# ***Interactive comment on “Future hydrological extremes: the uncertainty from multiple global climate and global hydrological models” by I. Giuntoli et al.***

**Anonymous Referee 4** Received and published: 3 March 2015

**Fig. 1.** PDFs of mean changes in high (HFI) and low (LFI) flows, annually and per season (DJF, MAM, JJA, SON) referring to North, Tropics and South latitude bands.

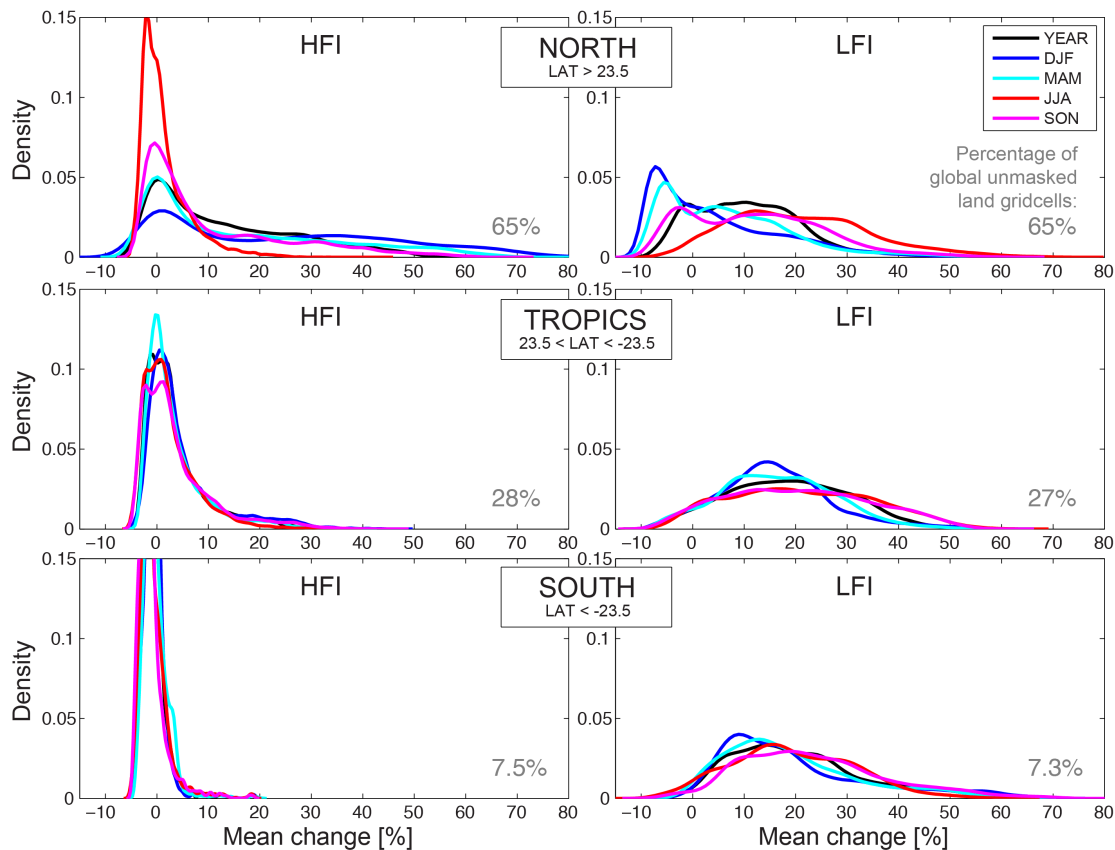
**Comment-1** My main concern is with the authors' use of multi-model ensemble mean. Although effort has been made to provide some information on the inter-model spread (e.g. variance), the manuscript can make a significant contribution to our understanding of the projections and modelling uncertainty of each GHM-GCM combination. In these respect, Figures 1, 3 and 4 can be provided as added illustration in the manuscript (or as appendix) by showing the changes in frequency of days under high and low flows from every GHM-GCM combination. In addition, given the focus of the study, I have strong recommendation on the use of winter half-year and summer half-year periods which is more representative of the relationship between rainfall and runoff, instead of climatologically defined seasons such as DJF and JJA.

**Comment-9** 8:13 : Referring to Figure 2, the authors state that “the mean change vary spatially in magnitude”. However, there is no information in Figure 2 to highlight spatial differences. In addition, it is not clear how the mean changes are derived. Are these spatially averaged changes? Can the authors clarify these two points?

We acknowledge the value of using winter half-year and summer half-year periods, however, having looked at the four seasons (DJF, MAM, JJA SON), our choice went for seasons for which changes are more marked (as shown in Fig.1). This time scale also facilitates direct comparisons with similar studies.

**Answer** This figure was crafted to provide a visual on the magnitude of mean changes that are mapped in e.g. Fig.1a of the manuscript. As written on the reply to Ref.2 we will update Figure 2. We provide in this document an updated version (Fig.1), which includes the seasons MAM and SON, in support to our reply to comment-1 on the choice of sub-annual windows of analysis.
